ADDENDUM No. 06

- A. Project Name: 2024 CAPITAL PROJECT PHASE 1.
- B. Building(s): MAIN BUILDING
- C. Owner: AFTON CENTRAL SCHOOL DISTRICT.
- D. Architect: HIGHLAND ASSOCIATES.
- E. Architect Project Number: 2025-005P.
- F. Construction Manager: SCHOOLHOUSE CONSTRUCTION SERVICES.
- G. Date of Addendum: DECEMEBER 17, 2025.

3
A-104
TYPICAL SECTION
@ EXTERIOR WELLS
SCALE: 3/4" = 1'-0"

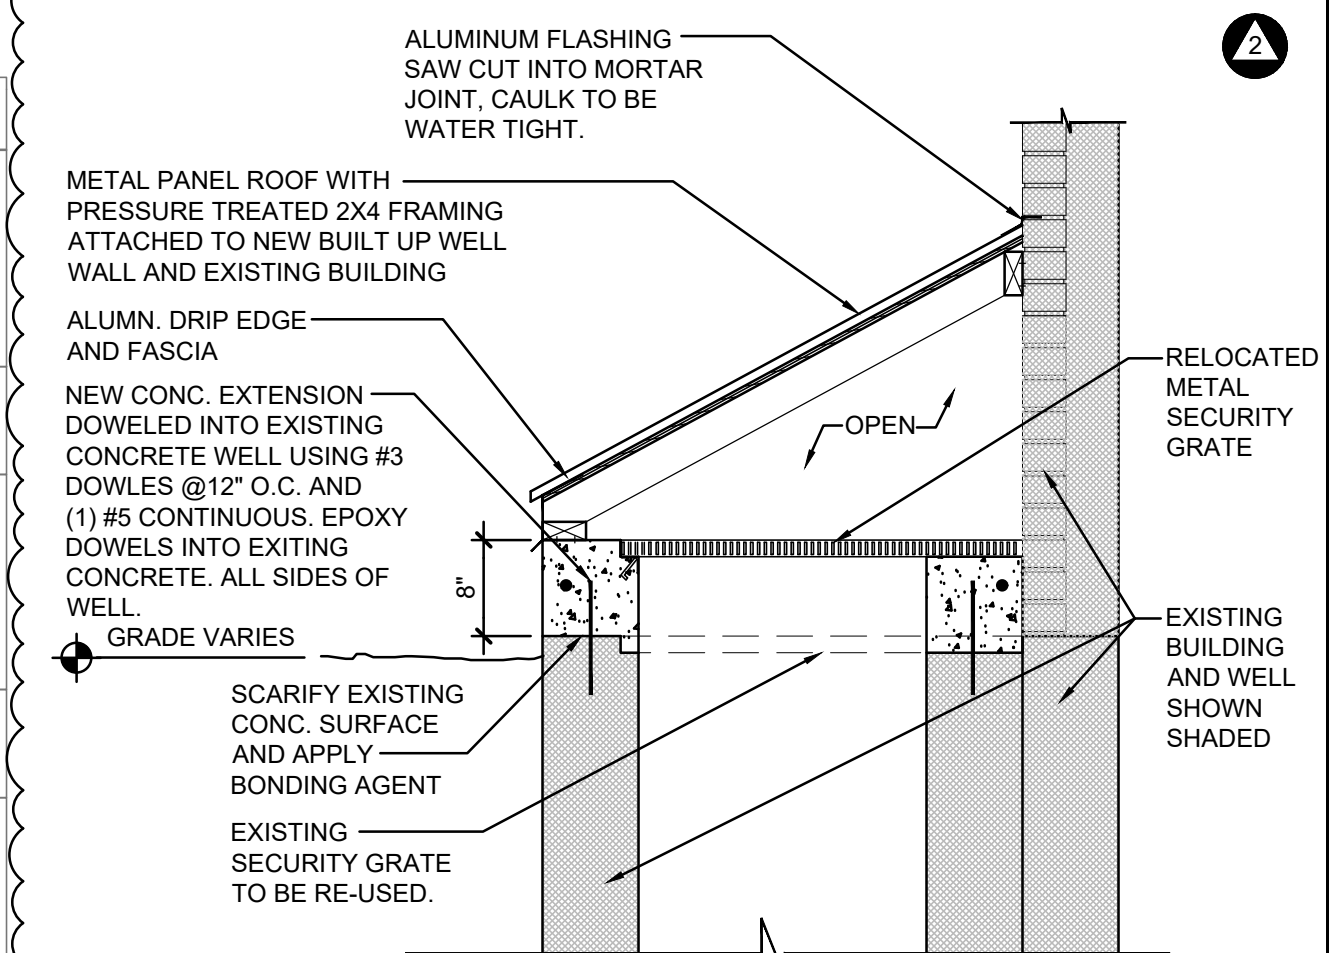
- ADDED ENLARGED EXTERIOR STAIR PLAN TAG.
- ADDED TYPICAL SECTION @ EXTERIOR STAIR WELLS AND CONSTRUCTION KEY NOTE 2.
- ADDED NOTE 3 AND HATCHED AREA AT BOY'S AND GIRL'S LOCKER ROOM 167 AND 169 INDICATING AREA WHERE CEILING IS TO BE REMOVED AND REPLACED TO ACCOMMODATE MECH DUCT WORK.

DRAWING TITLE:
**ROOF COMPOSITE PLAN
(PART A)**

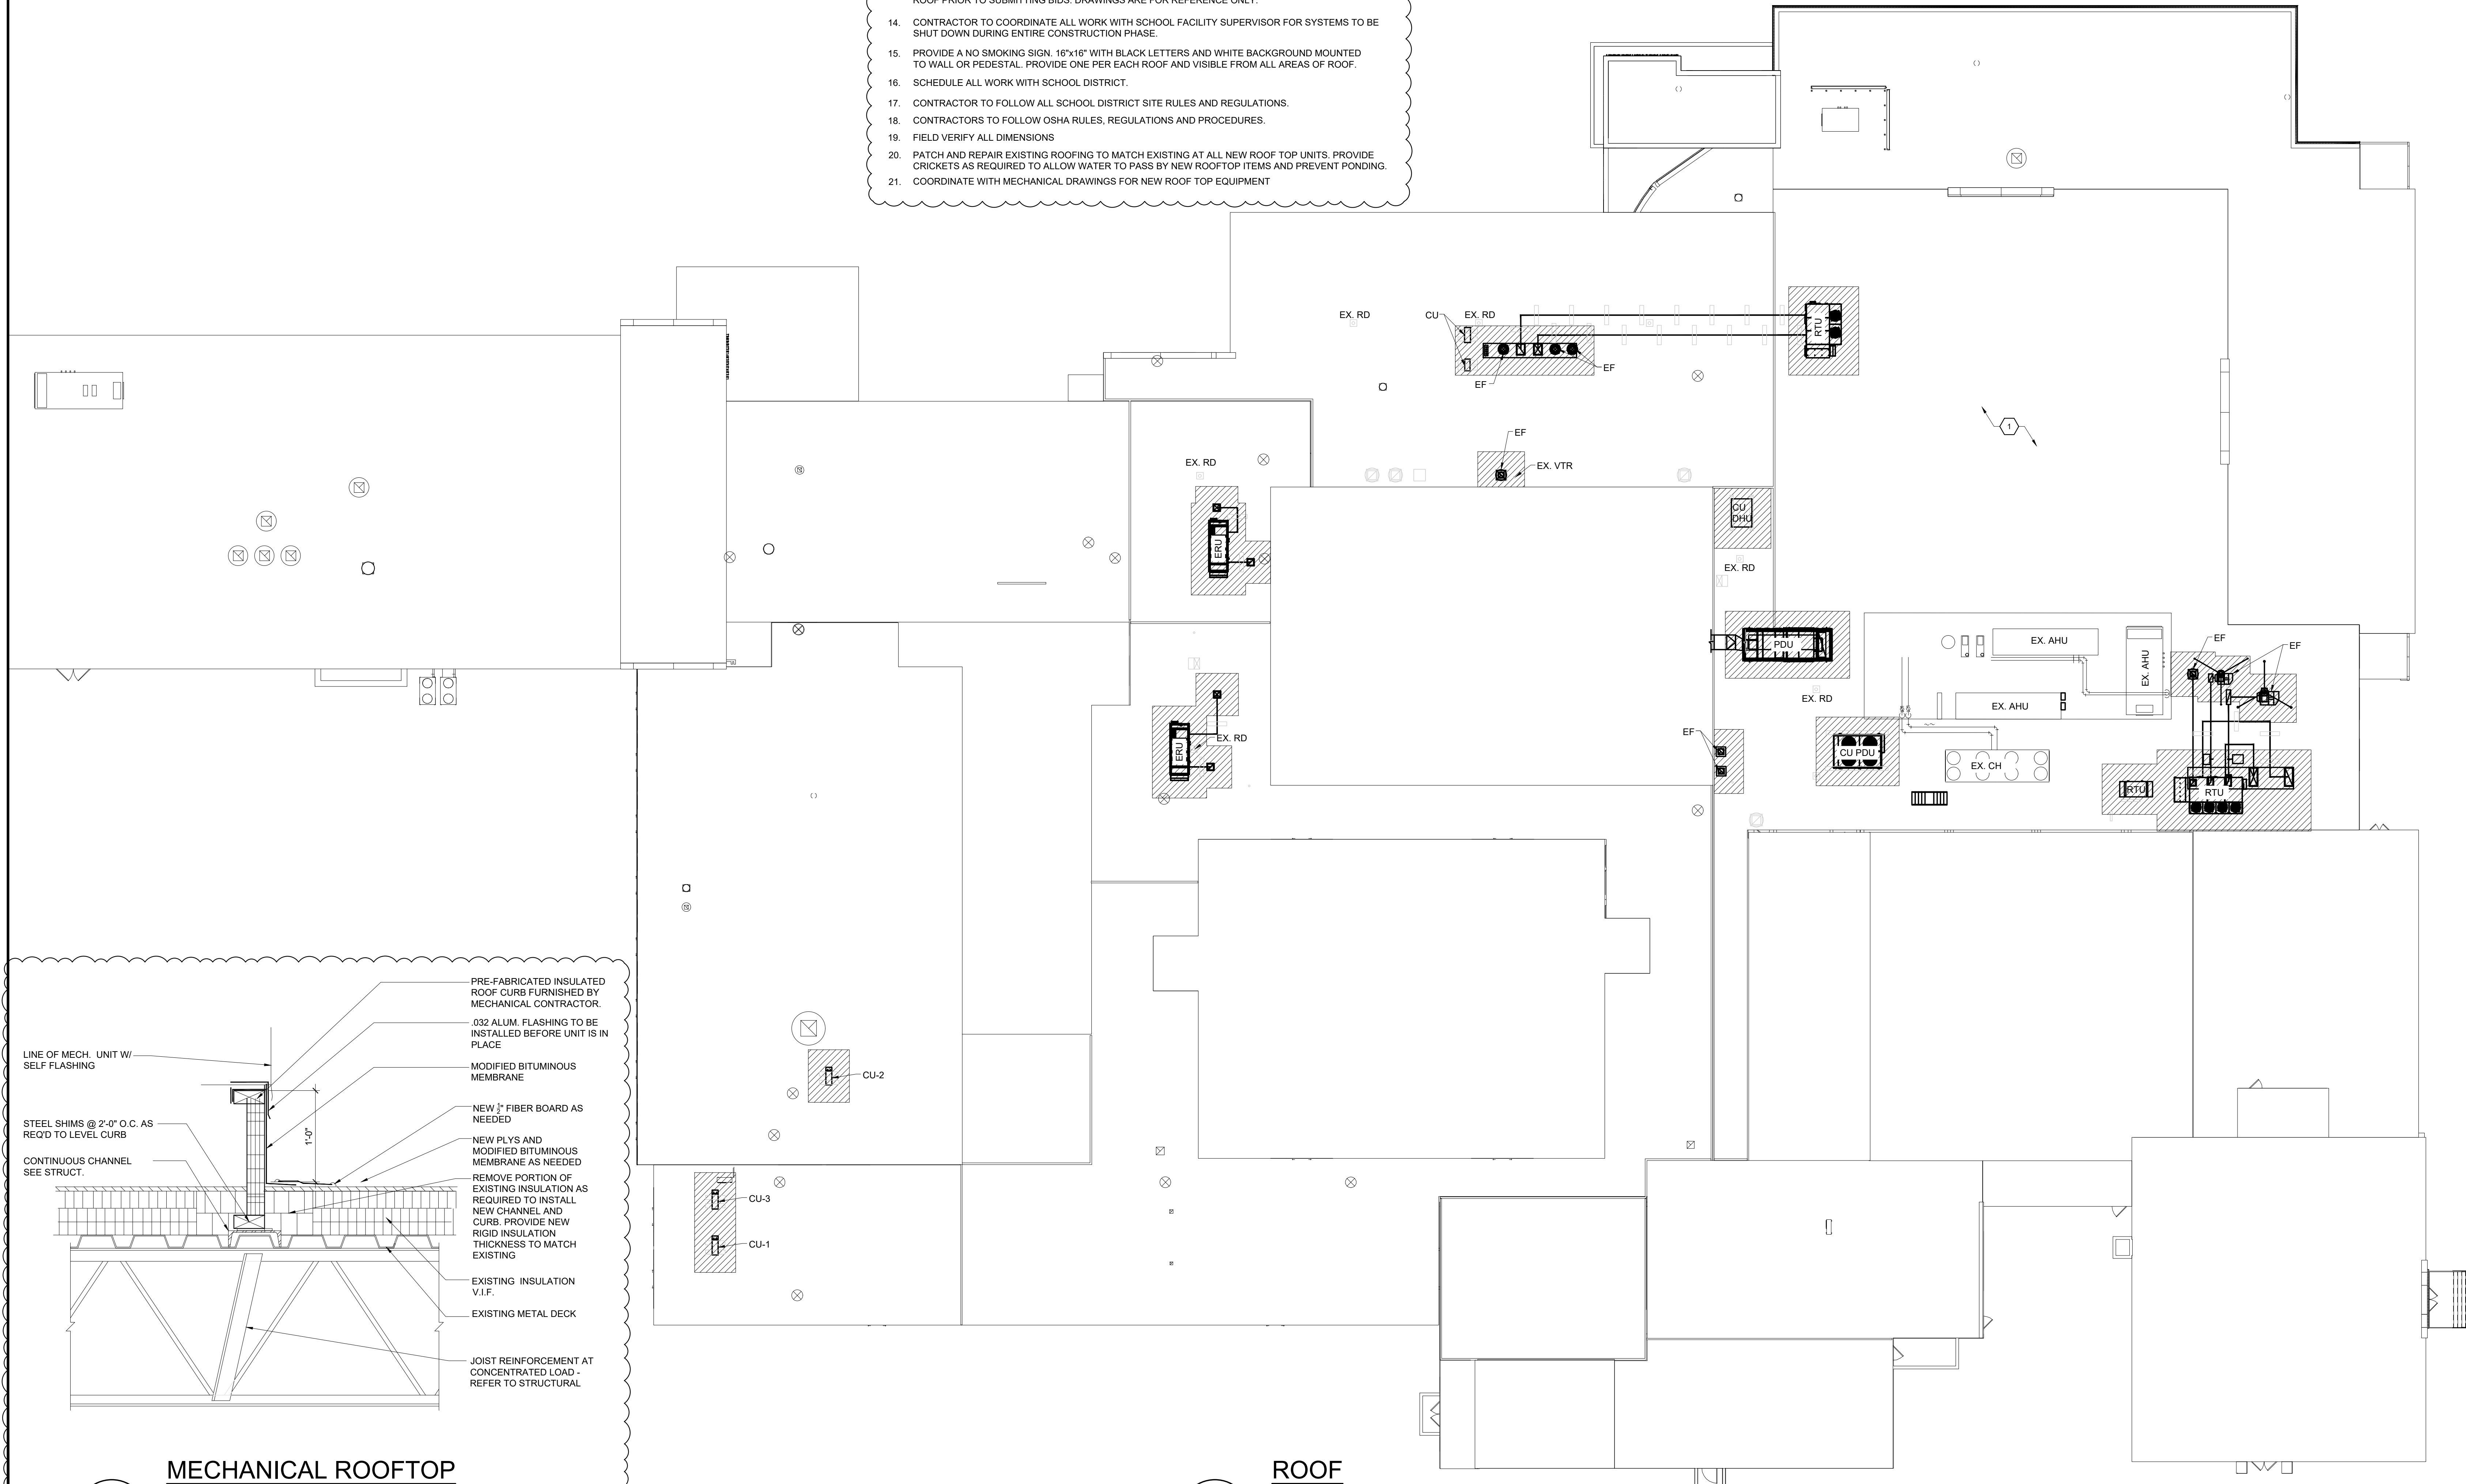
- ADDED ROOF GENERAL AND CONSTRUCTION NOTES
- HATCH TO INDICATE AREAS WHERE CONTRACTOR TO PATCH AND REPAIR ROOF TO MATCH EXISTING.
- ADDED MECH ROOFTOP EQUIPMENT DETAIL TO SHEET.
